MIDDLESEX COUNTY COLLEGE
Edison, New Jersey 08818-3050

ADDENDUM NUMBER 1

BID # 17-33- Digital Media Presentation System

JLC 131A

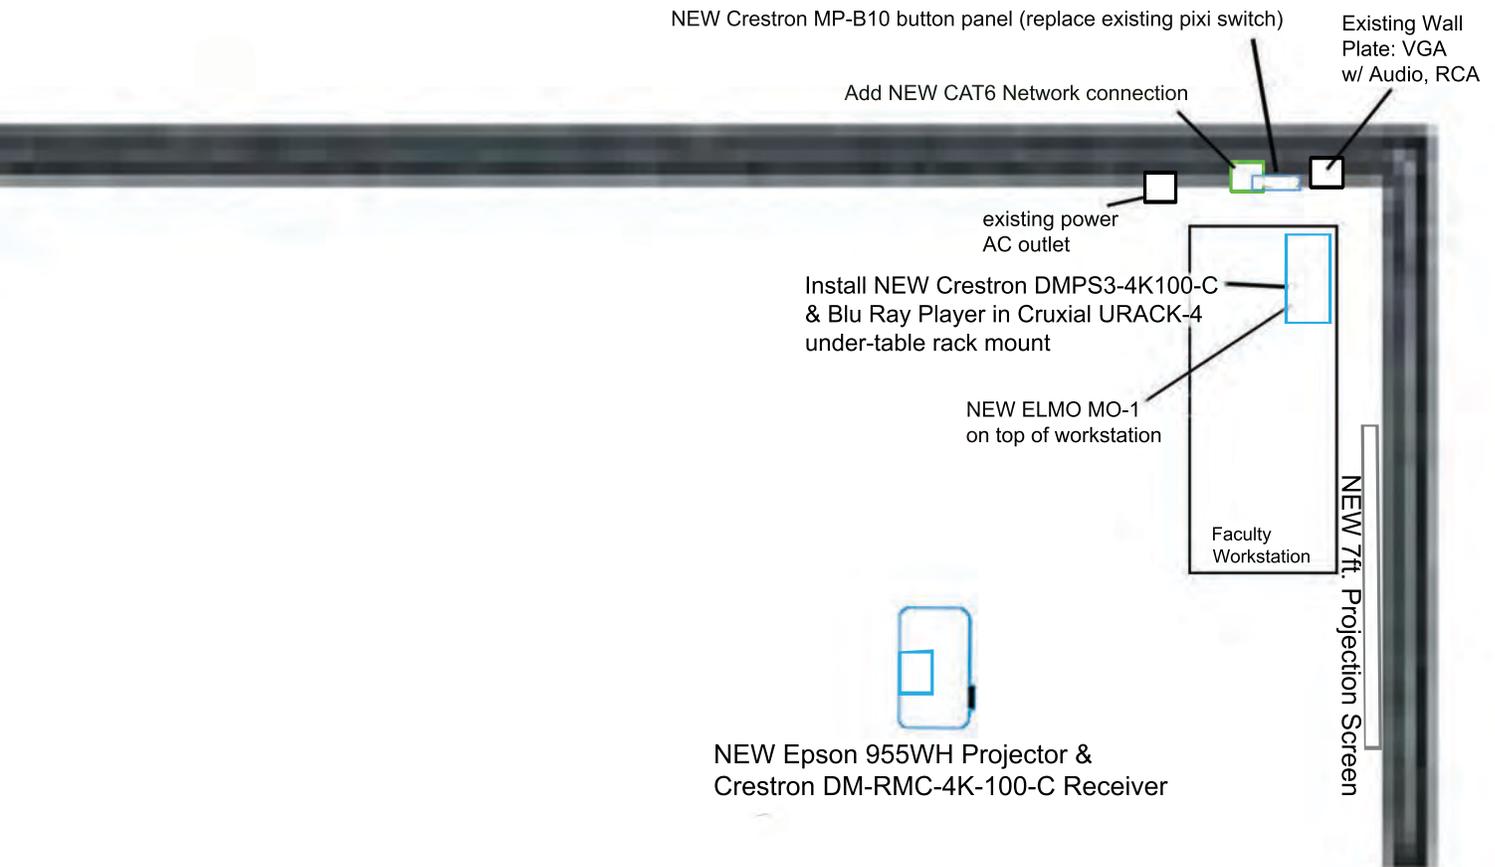
New Epson 955WH Projector

NEW 7ft. Projection Screen

JLC 221

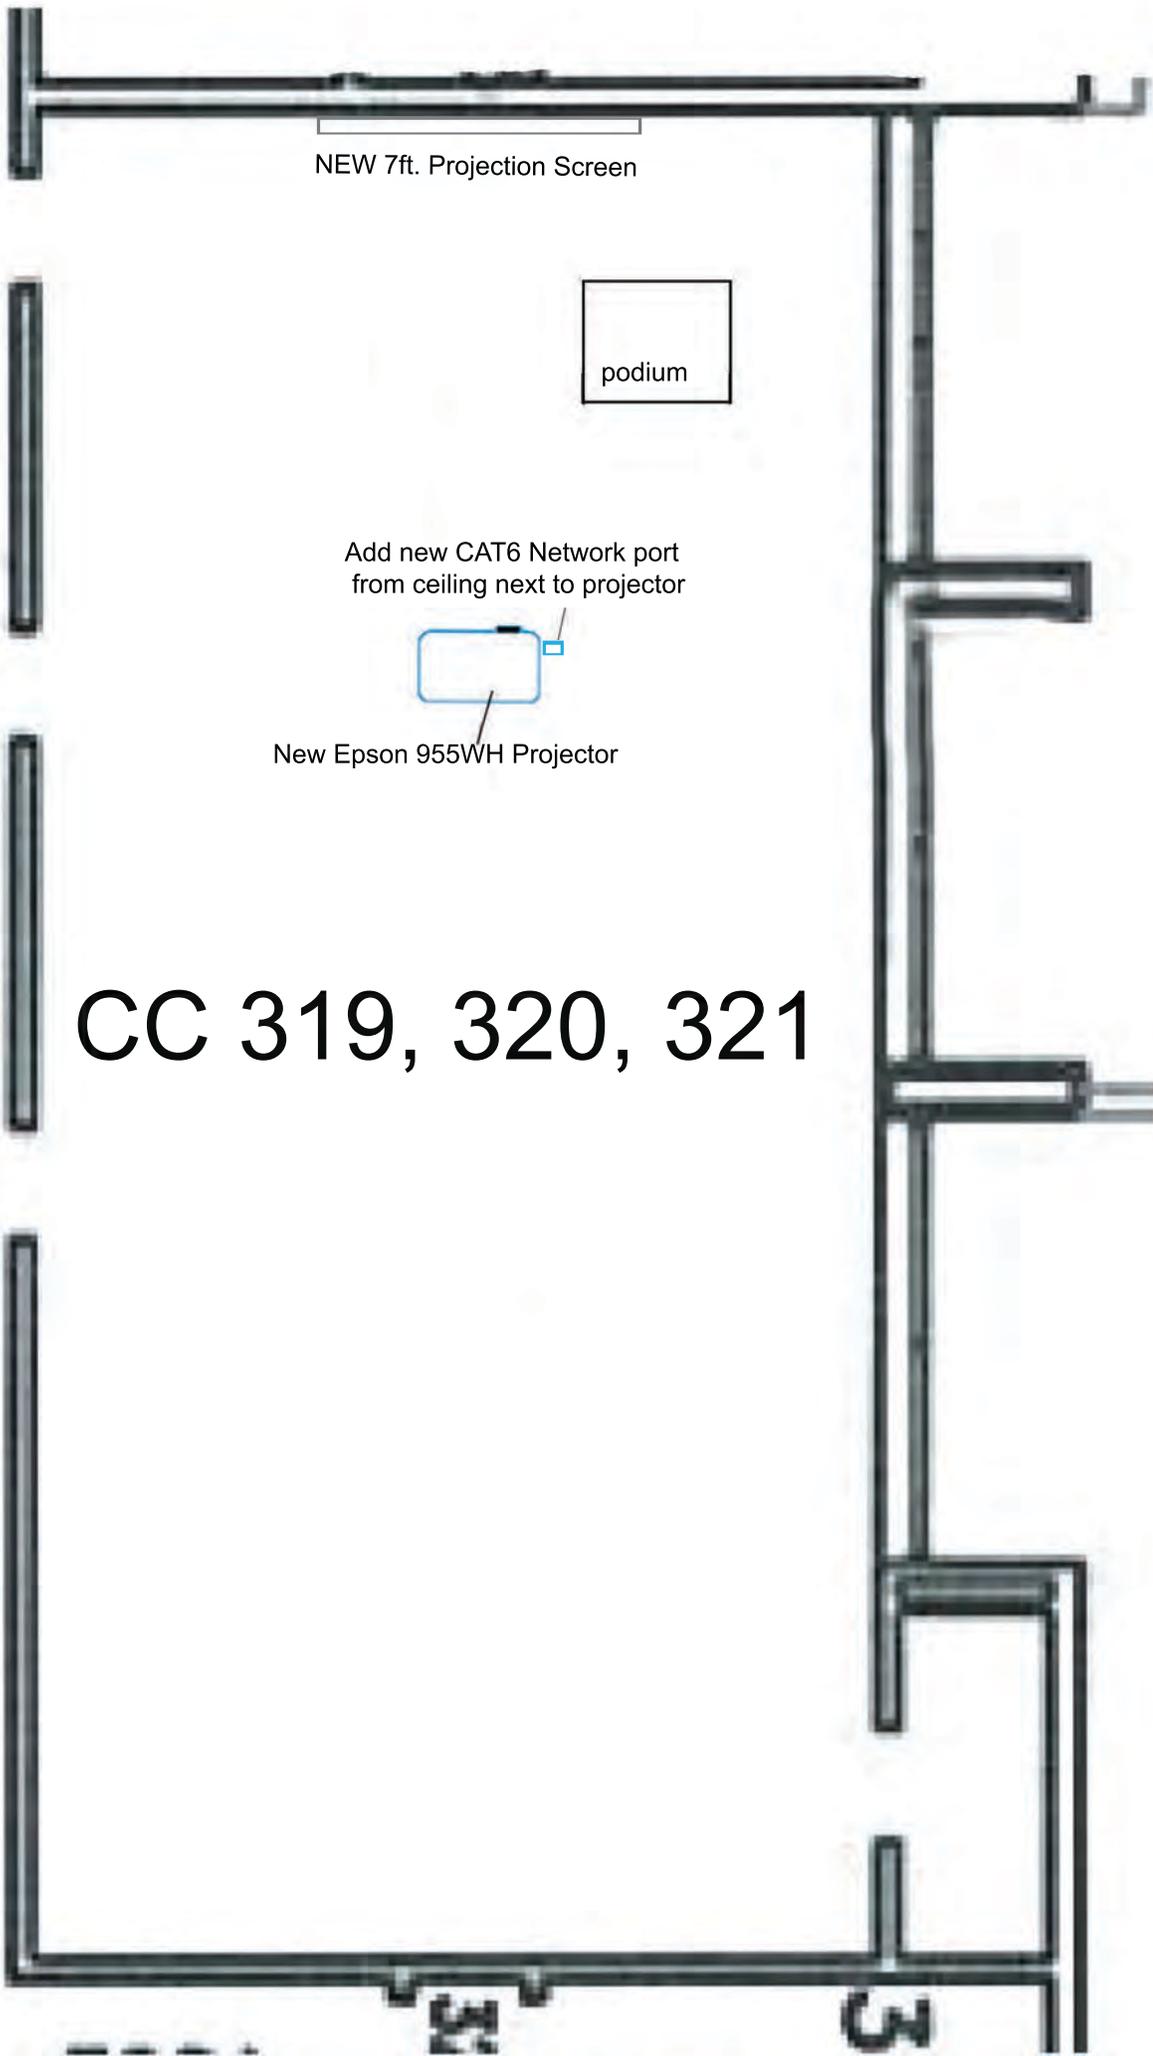
Add NEW Crestron DM-CBL-ULTRA-P Shielded plenum twisted pair cable from Crestron DMPS3-4K-100-C under Faculty Workstation to Crestron DM-RMC-4K-100-C receiver by projector.

Add NEW Crestron Cresnet cable from Crestron DMPS3-4K-100-C to Crestron MP-B10 button panel

Add New CAT6 Network cable from Crestron DMPS3-4K-100-C to New Network connection

SH 103

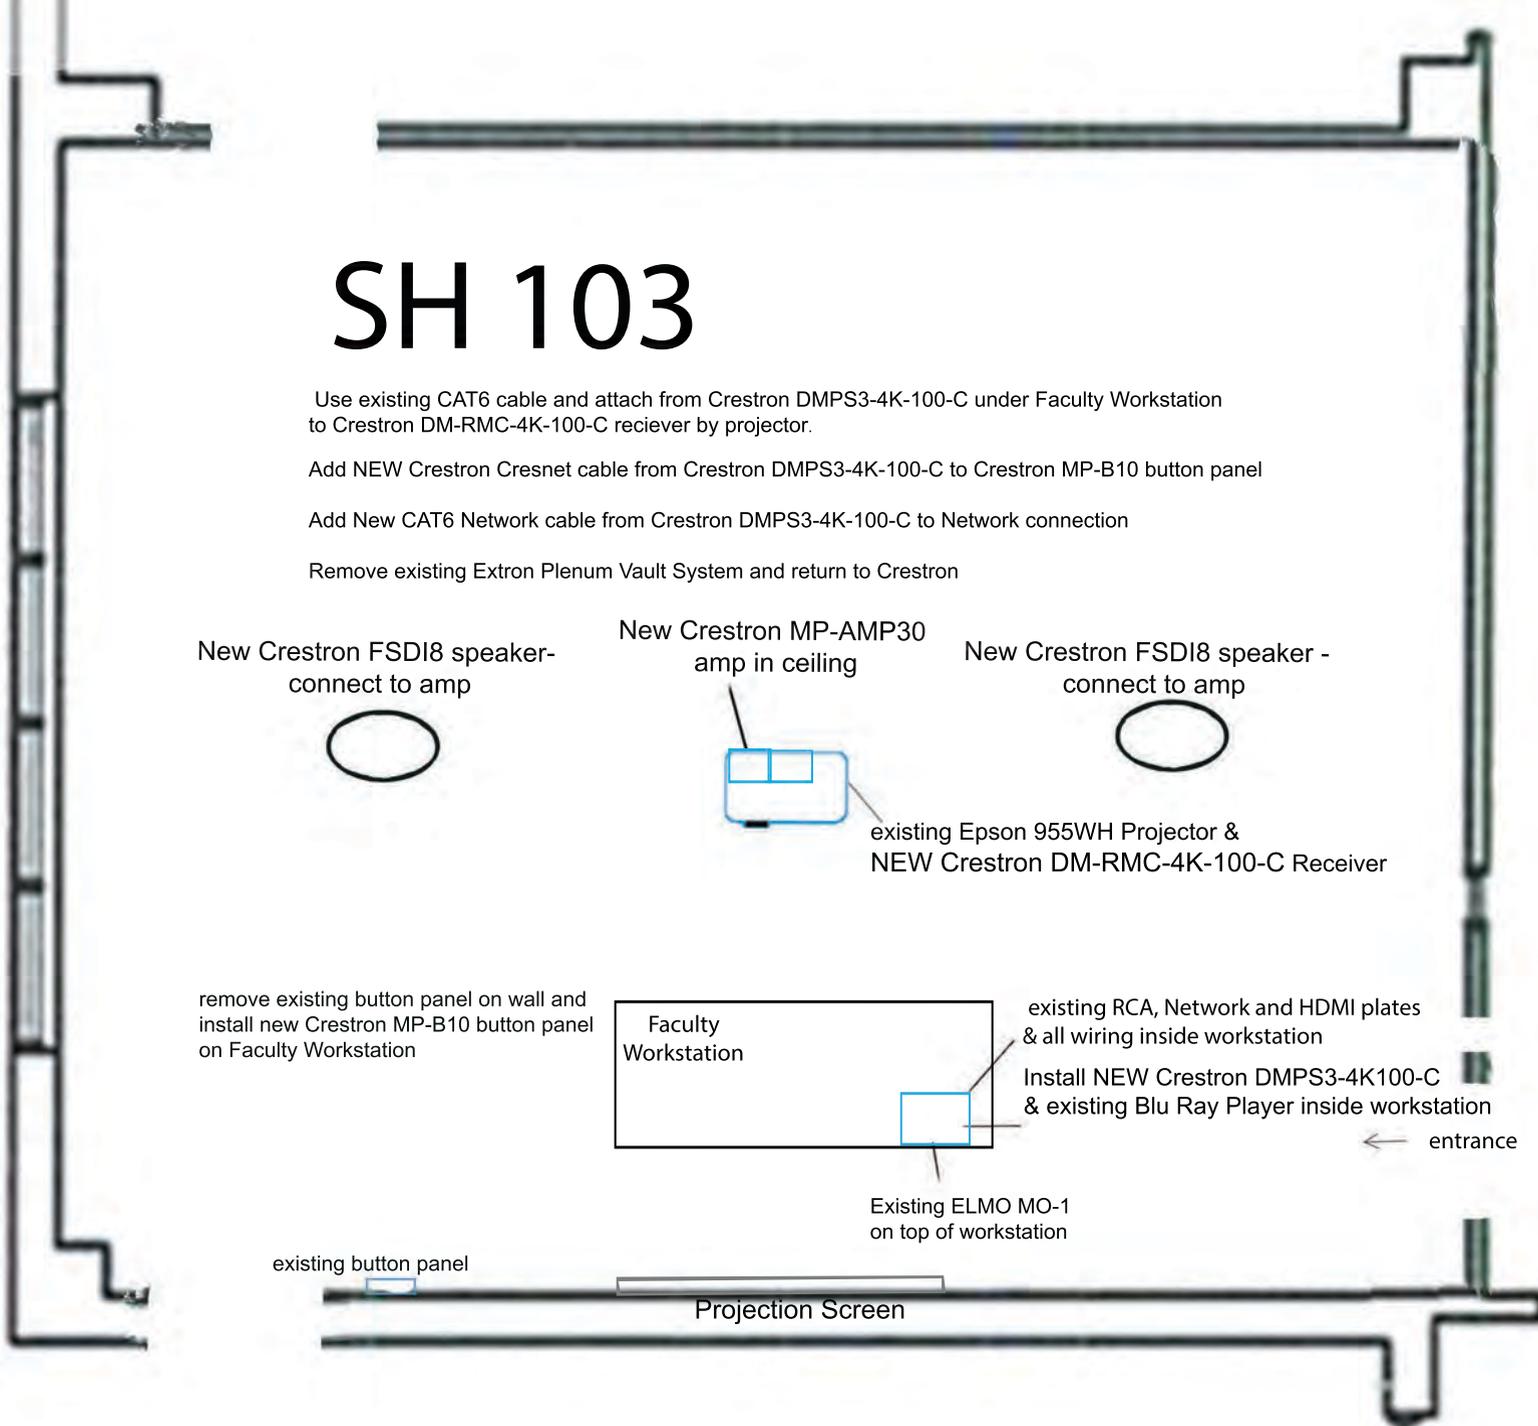
Use existing CAT6 cable and attach from Crestron DMPS3-4K-100-C under Faculty Workstation to Crestron DM-RMC-4K-100-C receiver by projector.

Add NEW Crestron Cresnet cable from Crestron DMPS3-4K-100-C to Crestron MP-B10 button panel

Add New CAT6 Network cable from Crestron DMPS3-4K-100-C to Network connection

Remove existing Extron Plenum Vault System and return to Crestron

remove existing button panel on wall and
install new Crestron MP-B10 button panel
on Faculty Workstation

SH 105

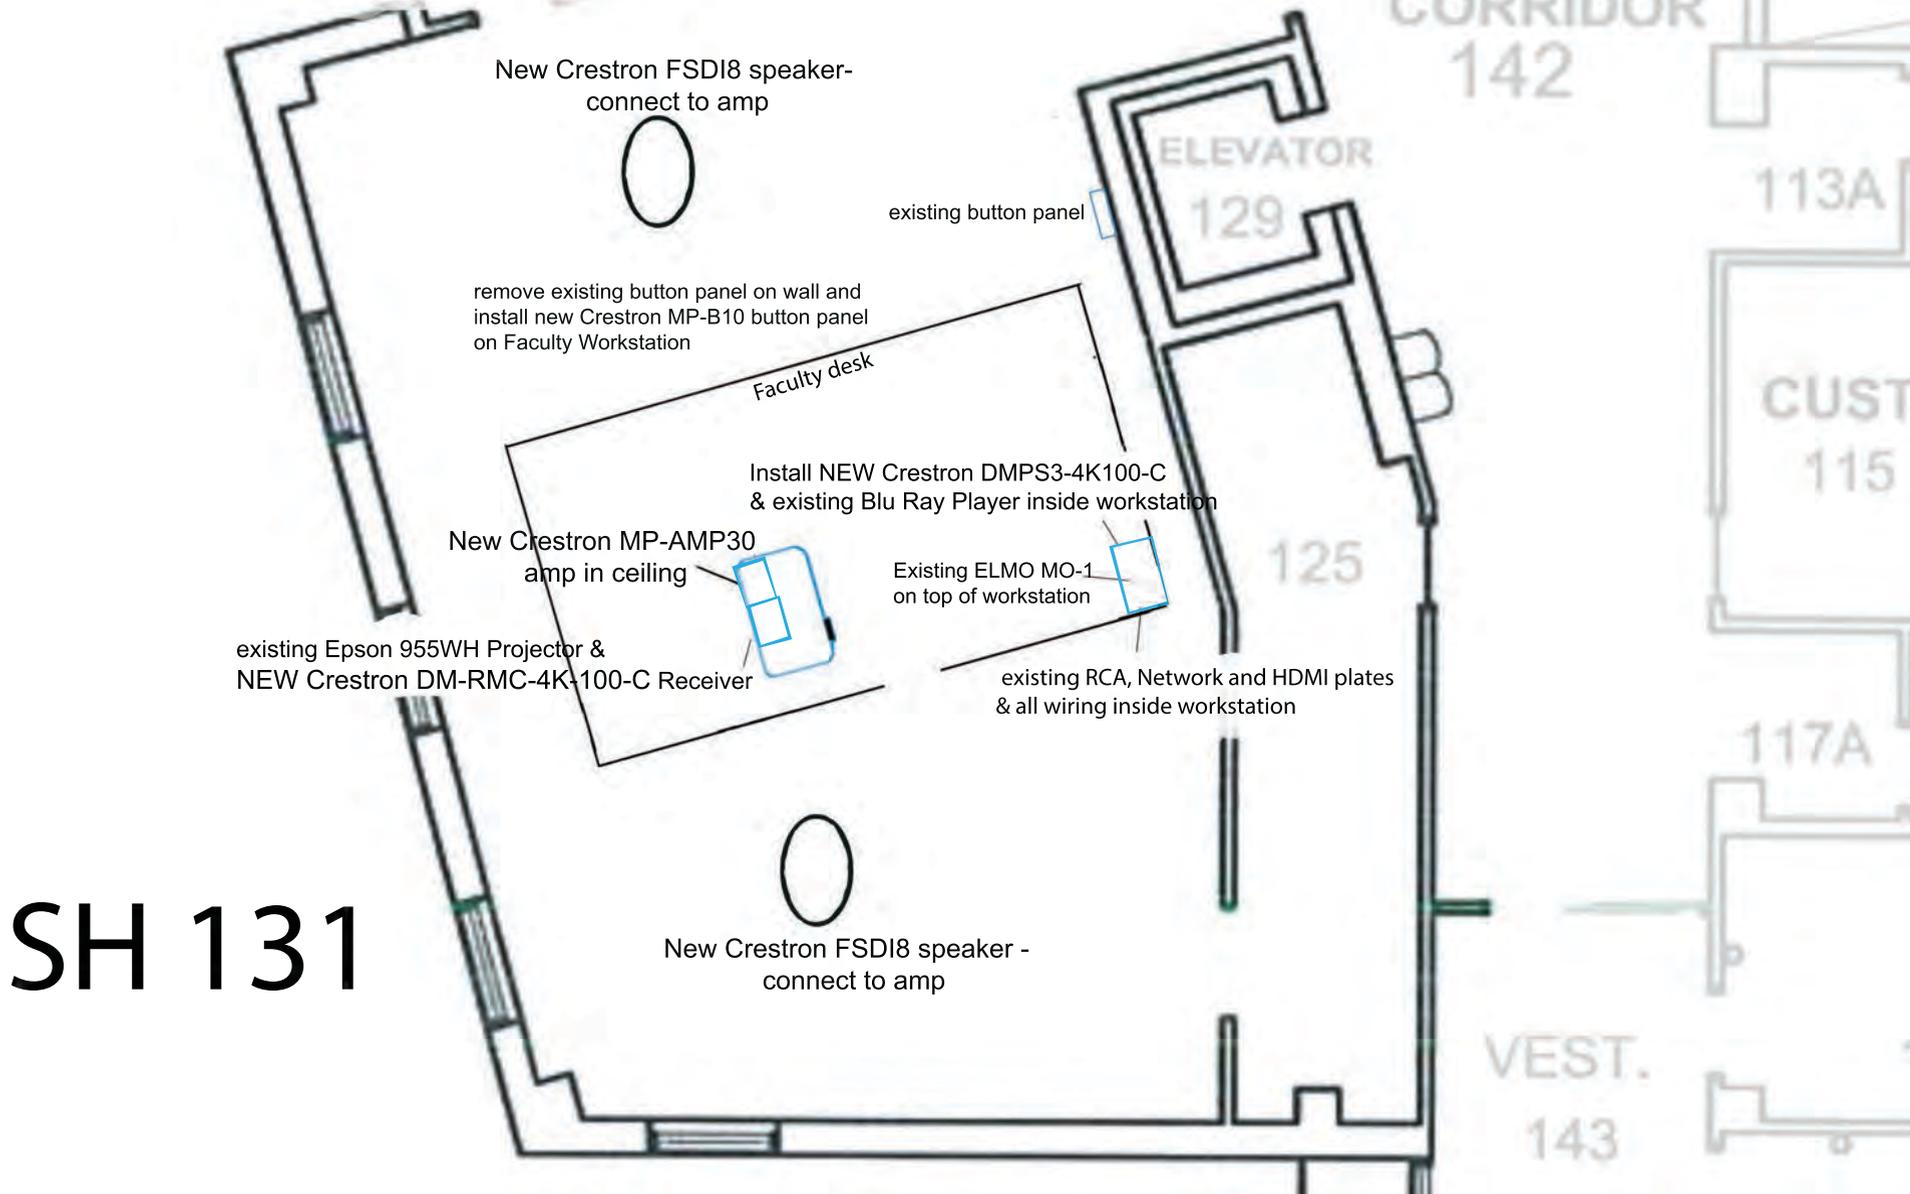
Use existing CAT6 cable and attach from Crestron DMPS3-4K-100-C under Faculty Workstation to Crestron DM-RMC-4K-100-C receiver by projector.

Add NEW Crestron Cresnet cable from Crestron DMPS3-4K-100-C to Crestron MP-B10 button panel

Add New CAT6 Network cable from Crestron DMPS3-4K-100-C to Network connection

Remove existing Extron Plenum Vault System and return to Crestron.

remove existing button panel on wall and
install new Crestron MP-B10 button panel
on Faculty Workstation

SH 201

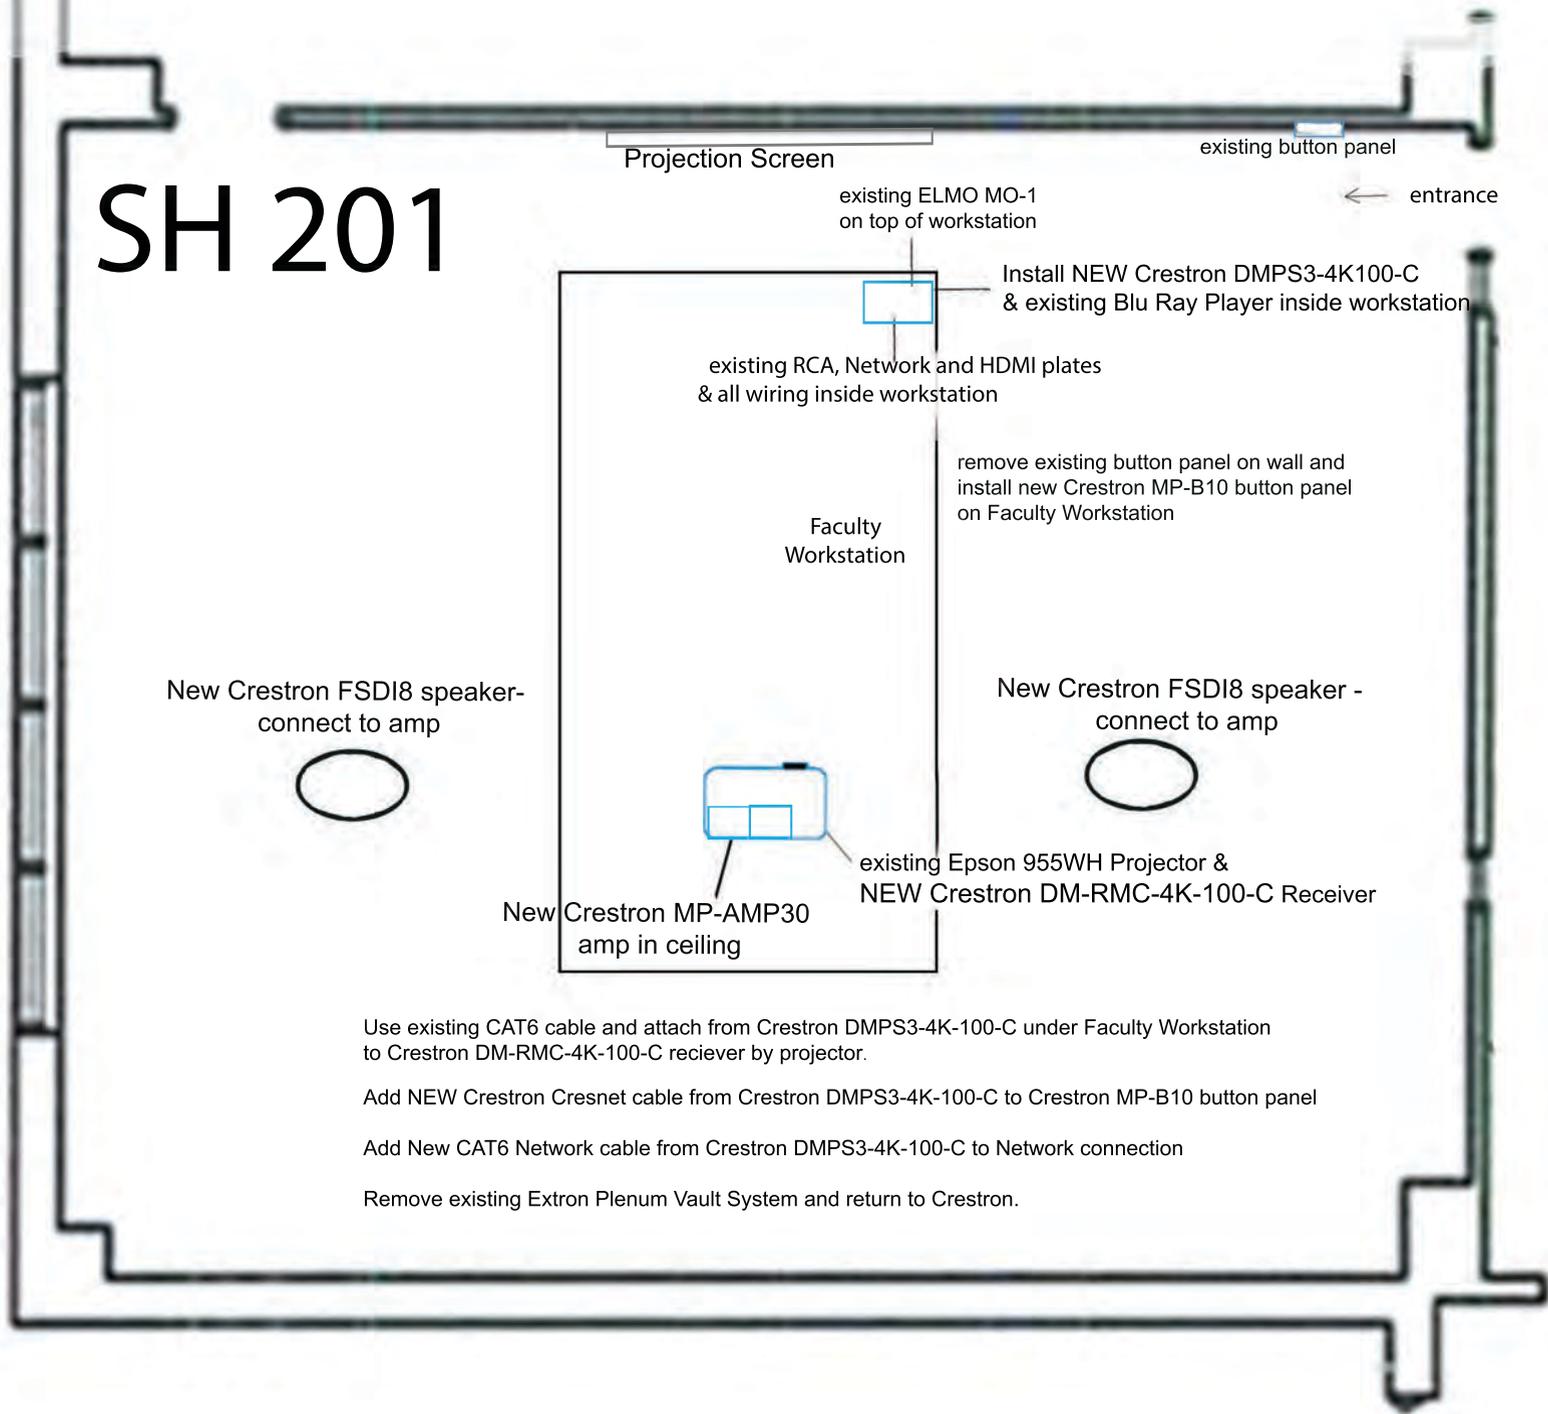
Use existing CAT6 cable and attach from Crestron DMPS3-4K-100-C under Faculty Workstation to Crestron DM-RMC-4K-100-C receiver by projector.

Add NEW Crestron Cresnet cable from Crestron DMPS3-4K-100-C to Crestron MP-B10 button panel

Add New CAT6 Network cable from Crestron DMPS3-4K-100-C to Network connection

Remove existing Extron Plenum Vault System and return to Crestron.
